Re: Application for Site Plan Review
100 & 200 Financial Park – Warehouse/Industrial Development
Franklin, Massachusetts

RE: **Response to Comments - Peer Review of Traffic Memorandum**
Proposed Warehouse Facilities
100/200 Financial Park, Franklin, MA

Re: Warehouse/Industrial Development
100 Financial Park
Site Plan Application – Traffic Peer Review

**Re: Warehouse/Industrial Development
100 Financial Park
Site Plan Application**

EXH-1

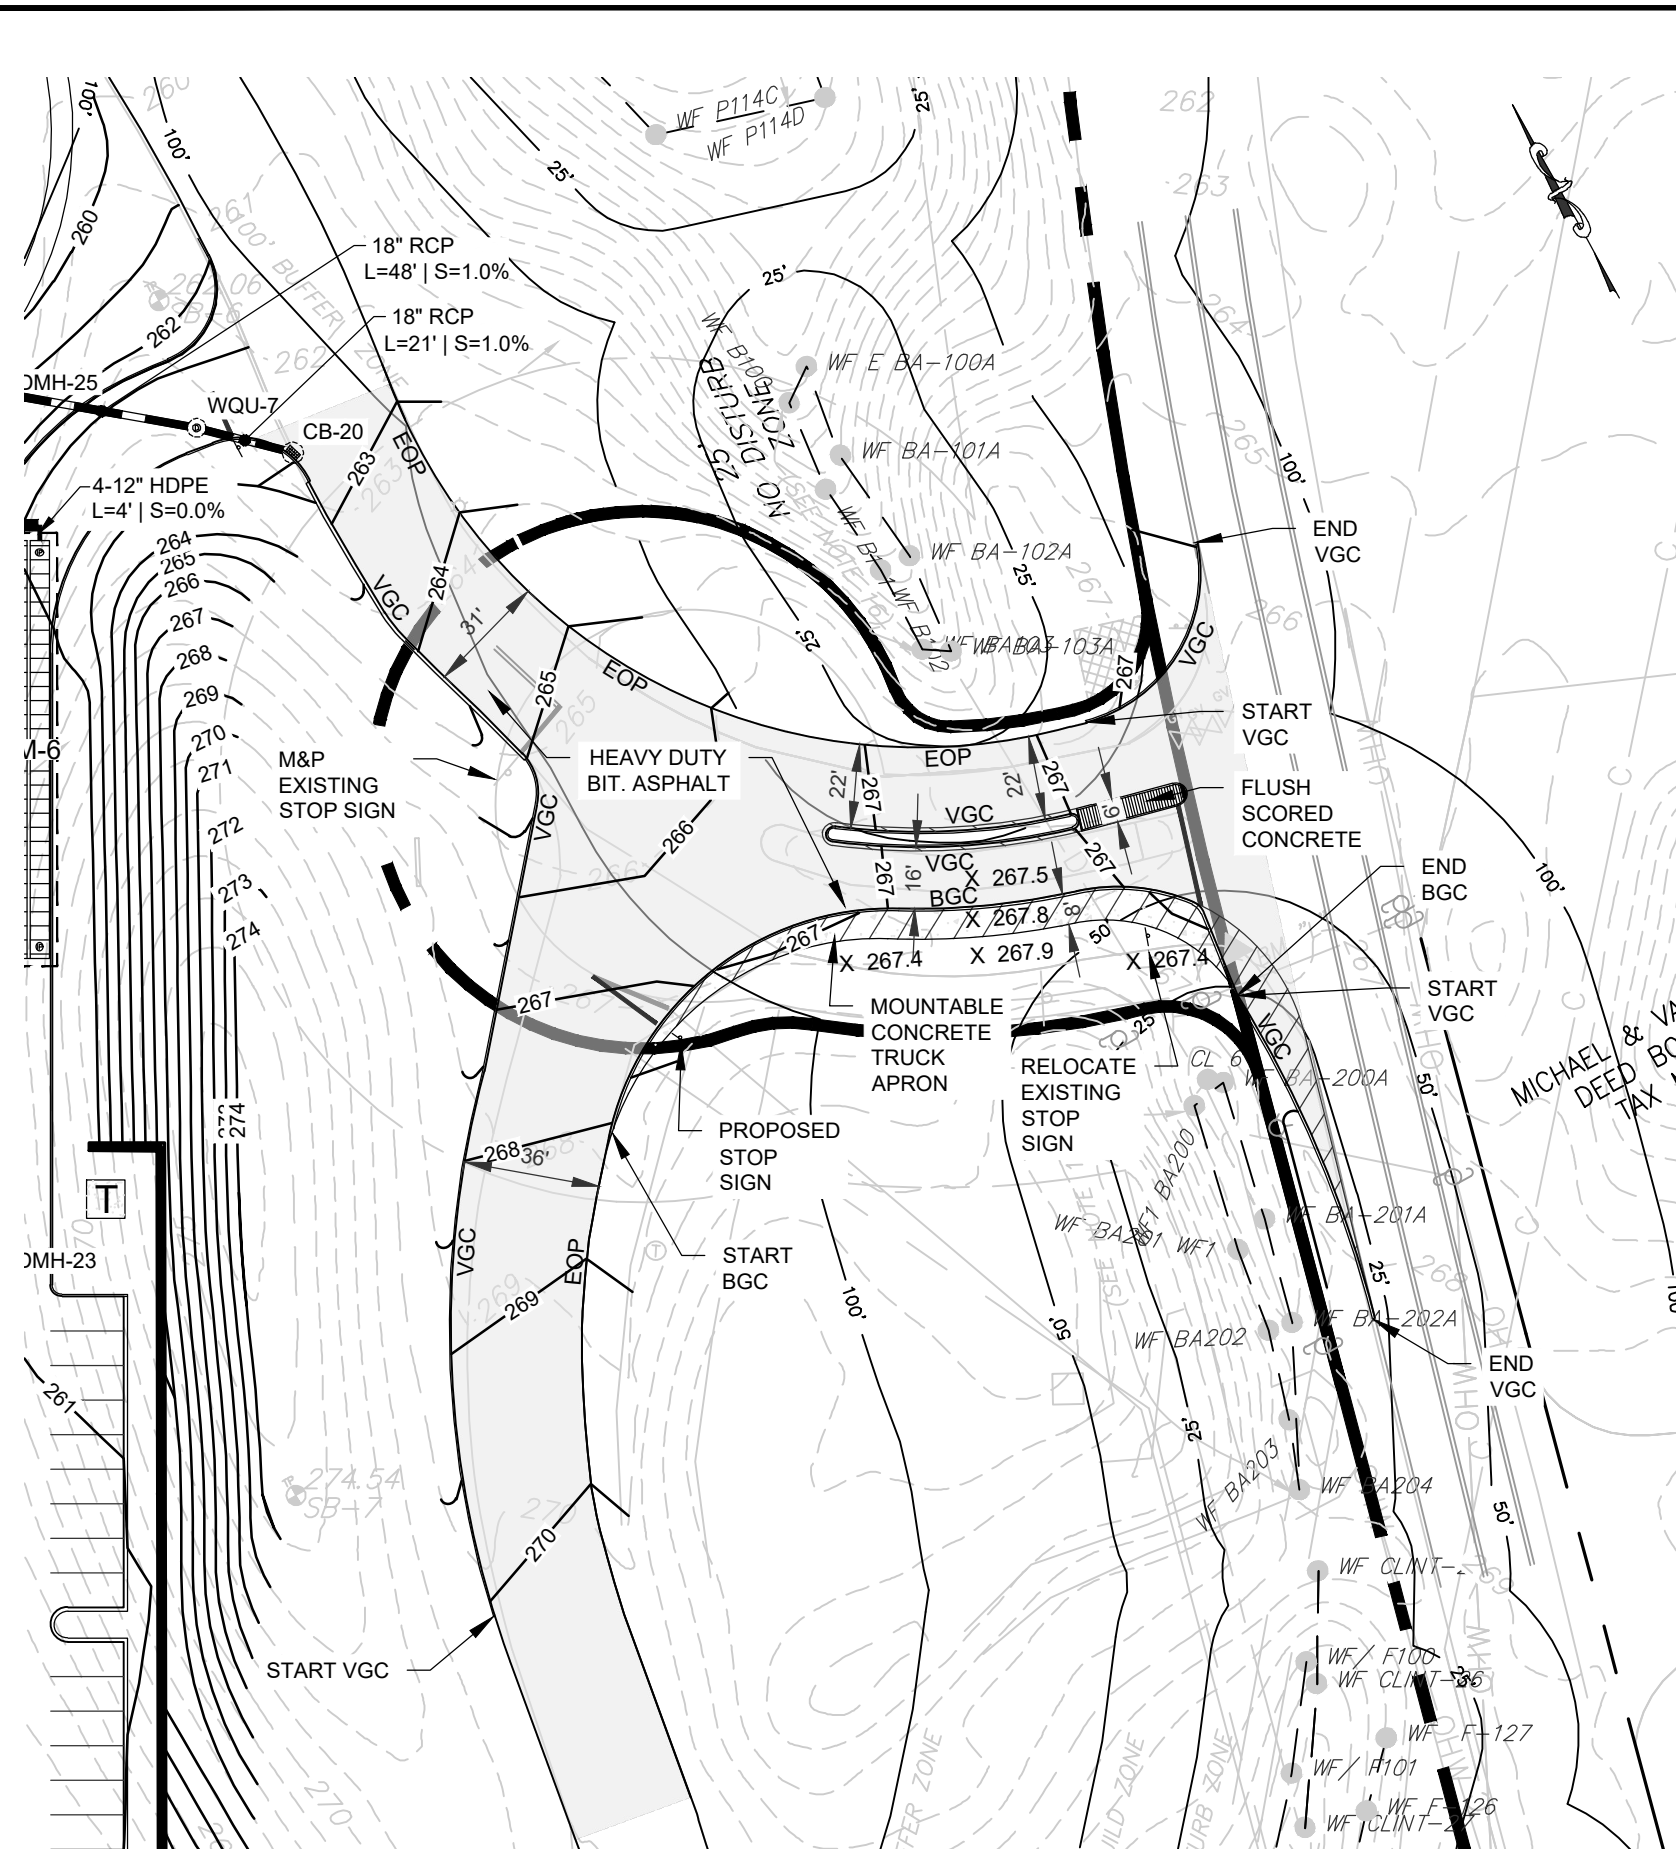
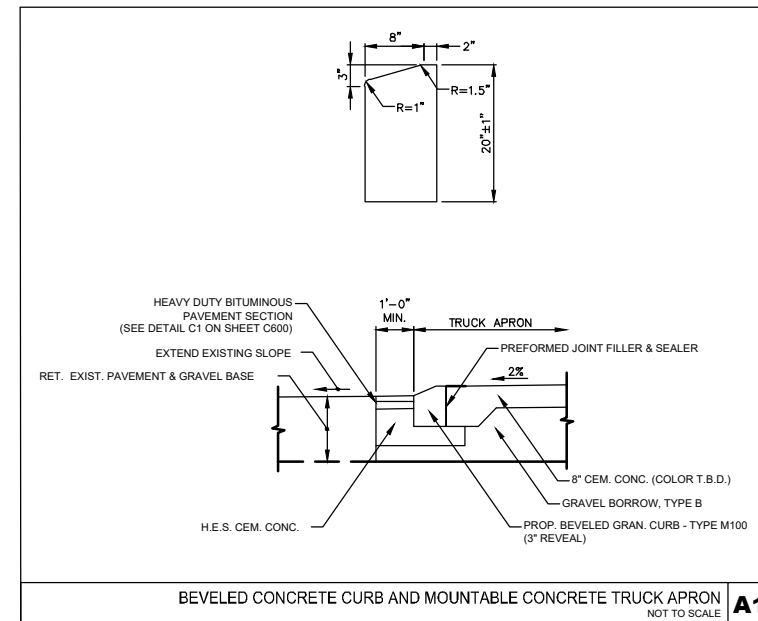
***BETA Supplemental Comment T15:** Please show the proposed stop sign location and widths of the egress lane and the gore area. A mountable or more distinct separation between the gored section and egress lane would be ideal to ensure that standard vehicles do not use the area as a second egress lane. BETA suggests installing a flush scored pavement area where the gore extension to the median is shown.*

BETA4: Please show the proposed stop sign location and widths of the egress lane and the gore area. A mountable or more distinct separation between the gored section and egress lane would be ideal to ensure that standard vehicles do not use the area as a second egress lane. BETA suggests installing a flush scored pavement area where the gore extension to the median is shown.

MDM Response T15: The Site Entrance Layout Plan (EXH-1) prepared by Highpoint Engineering (see **Attachment** for reference) has been updated to include the STOP sign locations and widths of the egress lane and the shoulder (gore) area. The plan has also been updated to include a mountable concrete truck apron instead of standard gore markings within the shoulder area along the egress lane and to provide a 6-foot-wide flush scored concrete extension of the median.

MDM4: The Site Entrance Layout Plan (EXH-1) prepared by Highpoint Engineering (see Attachment for reference) has been updated to include the STOP sign locations and widths of the egress lane and the shoulder (gore) area. The plan has also been updated to include a mountable concrete truck apron instead of standard gore markings within the shoulder area along the egress lane and to provide a 6-foot-wide flush scored concrete extension of the median.
